Urgent Field Safety Notice (FSN)

Replacing the power supply unit
for care beds in the Ecofit Xtra range

17.06.2024

Plug-in power supply SMPS - PS1102
200-240V, 50-60Hz, 2,4A, IPX6
Model number: 503605

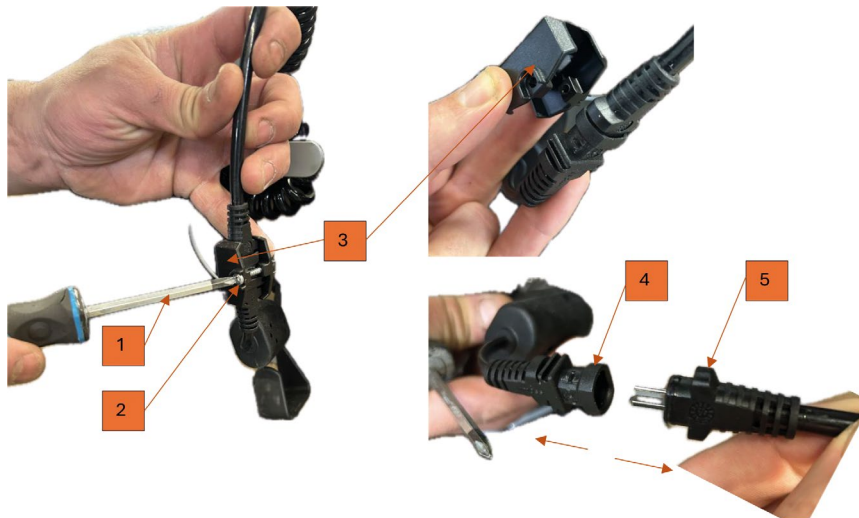
Please replace the MC115L-90-EU power supply unit with the PS1102 power supply unit provided free of charge by tecfor care for care beds from the Ecofit Xtra range in your inventory or during the next maintenance. Instructions for replacement can be found in the appendix to this letter.

1. To remove the previously installed power supply unit, use a screwdriver (1) to loosen the screw (2) on the safety cap of the plug connection.
2. You can then remove the protective cap (3) with little effort.
3. Now release the plug connection (4+5) by pulling in the opposite direction.

1. Take the new plug from the scope of delivery and fit it in the opposite direction as described in the "Disassembly" section.
2. Once steps 3-1 have been carried out, the power supply unit is ready for use and can be reconnected to the mains supply.
